Department of Pesticide Regulation

MEMORANDUM

SUBJECT: Response to comments by Dow AgroSciences on DPR-HHAB's draft 1,3-Dichloropropene Risk Characterization Document dated Aug. 31, 2015

Page 155/Paragraph 1: “Use of the reentry worker exposure study data conducted by the registrant may have led to estimates higher than the actual exposure for this worker.”

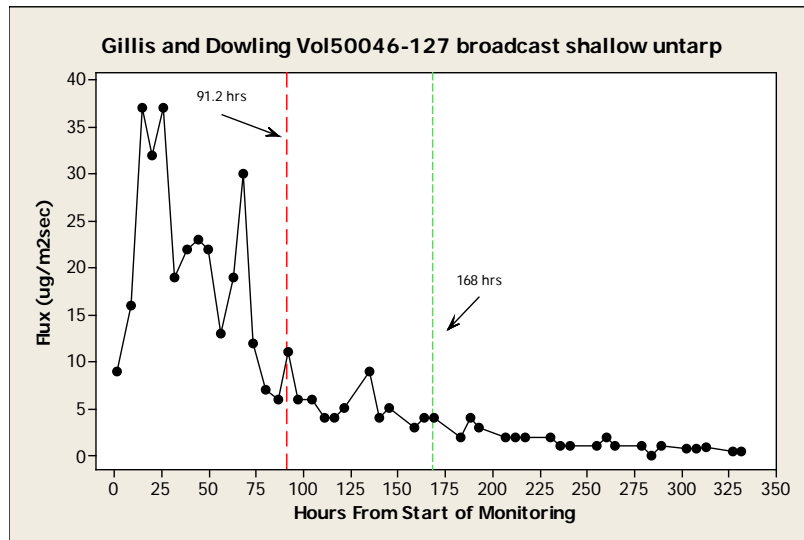
DAS Comments:

DPR-HHAB response: In response to this comment, an analysis of the flux profile for Field 1 broadcast shallow shank untarped application from the Gillis and Dowling flux study (Gillis, 1998) is presented below:

It is true that the general pattern of the flux profile is exponential decline after the first peaks are reached at 15 and 37 hrs. However, fitting that exponential would be difficult to impossible. TableCurve® software was used to fit the decline and, as expected, no acceptable fit could be found. There is a decline, but fitting a single viable function is impossible. The interval between 3.8 days (91.2 hrs) and 7 days (168 hrs) is shown as vertical lines. It is clear that the flux values in this interval are not monotonically decreasing. In order for DAS's argument to be strictly correct all the flux values in that interval should be monotonically decreasing. However, it appears that it is likely that the flux at 91.2 hrs is numerically larger than the flux at 168 hrs. This does not mean the flux between those two time points is statistically different.

Flux is only one of the variables that produce air concentrations to which workers will be exposed. Although it is true that in air dispersion modeling, air concentrations are directly proportional to flux, that is with all other factors held constant. So, the uncertainty in differences in meteorology between these two time points should be considered. In addition, if the air concentrations associated with these flux values were modeled using an air dispersion model, it should be noted that air dispersion models are considered to generally produce air concentrations within a factor of 2 of the actual air concentrations generated by that flux. DAS states that the difference is approximately a factor of 2, which is within the model uncertainty. This supports not changing the re-entry worker exposure estimates.
